**Addendum #2
Lakeland School Corporation
Maintenance Building**

Date: April 21, 2026
Project: Maintenance Building
Project #: 25082
Pages: 1 of 2 (8-1/2x11) pages
Bid Dates: THURSDAY, May 7th, 2026 at 11:30 am (prevailing local time)

BUILDING TO SHIFT
WEST TO THIS
LOCATION

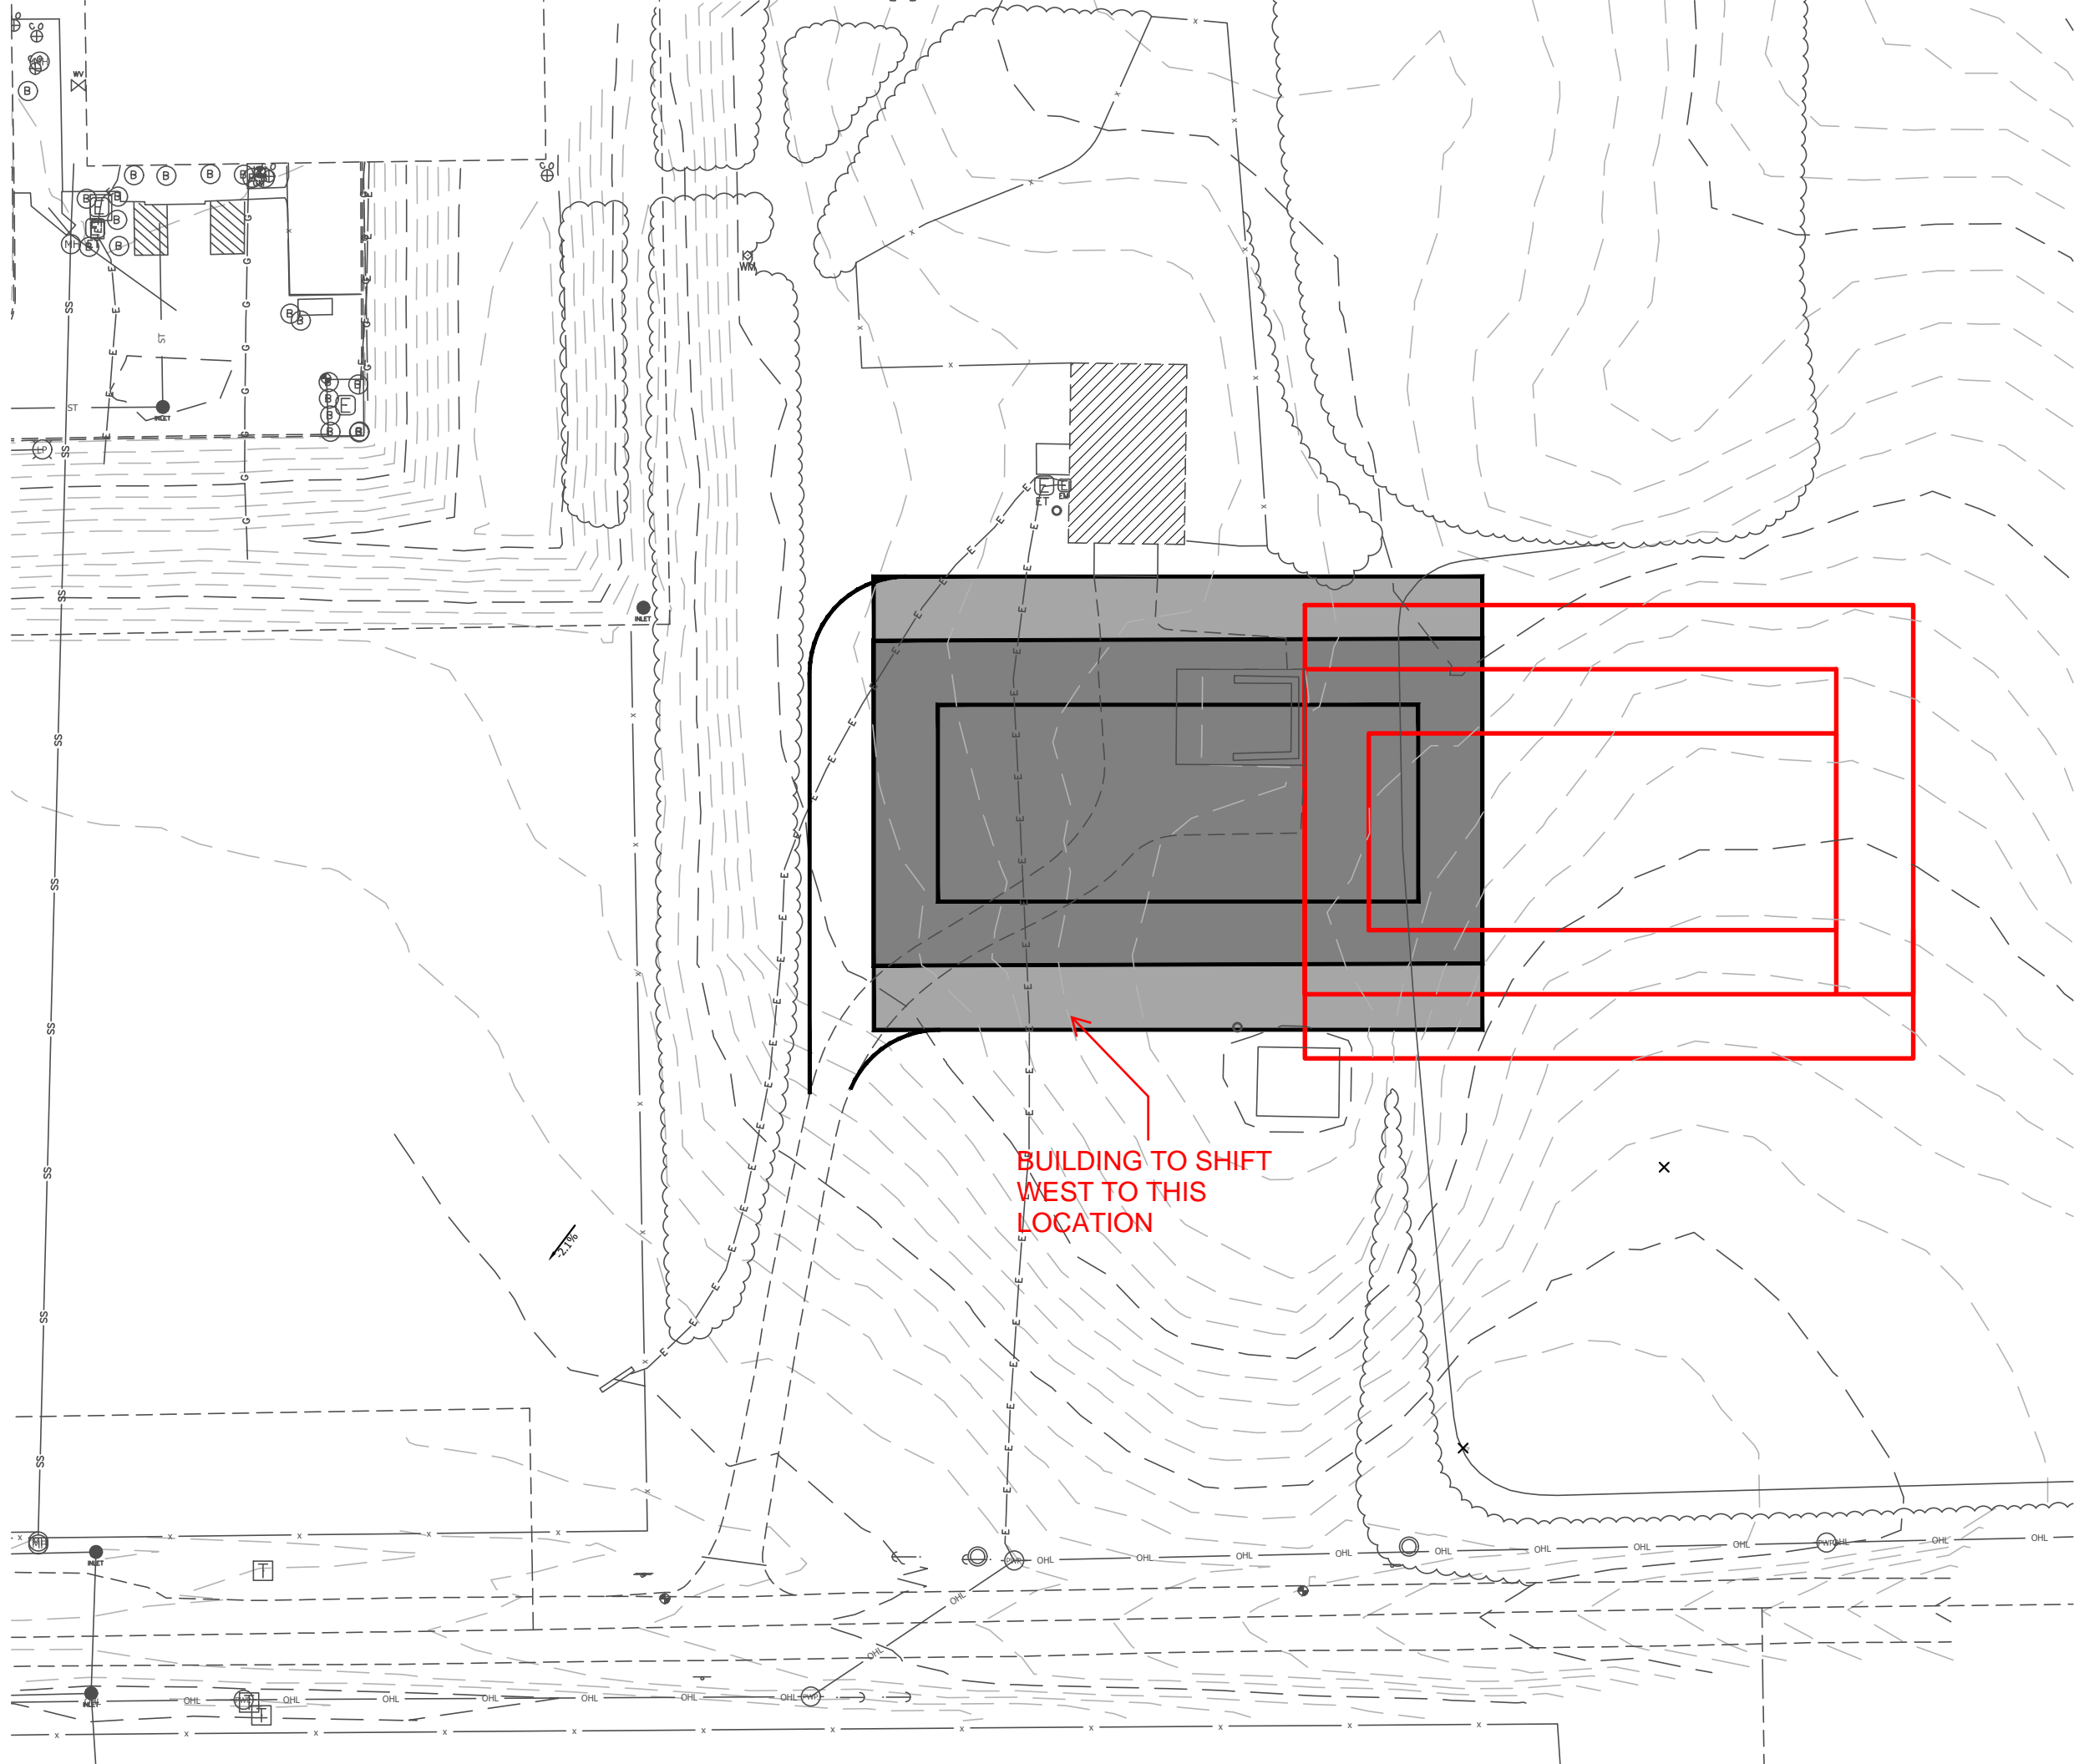
1. *After the preliminary review of the soil borings, the site location will be shifted as shown on the attached alternate siting location document. The civil will be updated for Addendum No 3. which will be issued when the drawings are updated.*
